Access Compliance Report Public Rights-of-Way (Curb Ramps)

Main Street: 17TH_ST Cross Street: BRENNAN_WAY Location: NW

ADA ID: RPRK220125123706 Ramp Type: Type 4 - Parallel Initial Pass/Fail: Fail Overall Compliance: No Severity Score: 2

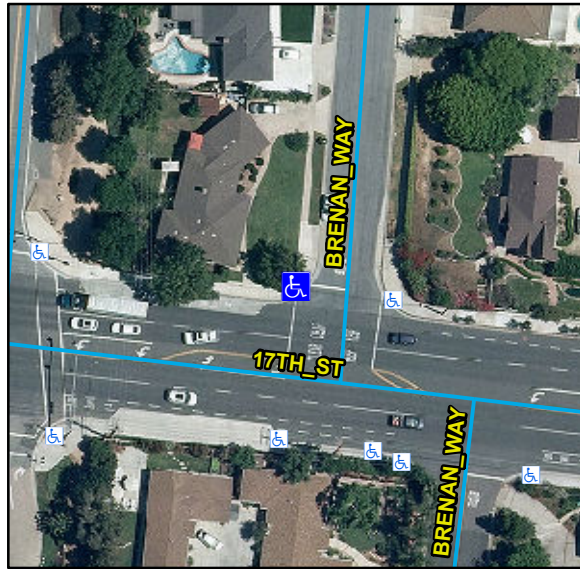
Compliance	Description	Data	Compliance	Description	Data
N/A	Ramp Length LT (in)	104	N/A	Ramp Length RT (in)	99
Yes	Ramp Width LT (in)	88	Yes	Ramp Width RT (in)	88
Yes	Ramp Run Slope LT (%)	6.3	Yes	Ramp Run Slope RT (%)	6.8
No	Ramp Cross Slope LT (%)	3.5	No	Ramp Cross Slope RT (%)	2.3
N/A	Landing Present	N/A	N/A	DWS Provided	N/A
N/A	Landing Length (in)	N/A	N/A	DWS Contrast	N/A
N/A	Landing Width (in)	N/A	N/A	DWS Length (in)	N/A
N/A	Landing Run Slope (%)	N/A	N/A	DWS Full Width	N/A
N/A	Landing Cross Slope (%)	N/A		DWS Offset Type	N/A
N/A	Landing Movement Obstructed?	N/A	N/A	DWS Offset Left (in)	N/A
	Landing Movement Type	N/A	N/A	DWS Offset Right (in)	N/A
N/A	Landing Shared	N/A			
N/A	Clear Space	Yes			
N/A	Clear Space To Crosswalk (in)	N/A			
N/A	Marked Crosswalk 1	No	N/A	Marked Crosswalk 2	No
	Crossing 1 Direction	S		Crossing 2 Direction	E
	Marked Crosswalk 1 Width (in)	N/A		Marked Crosswalk 2 Width (in)	N/A

Remove & Replace Curb Ramp With Two New Directional Ramps or Equivalent.
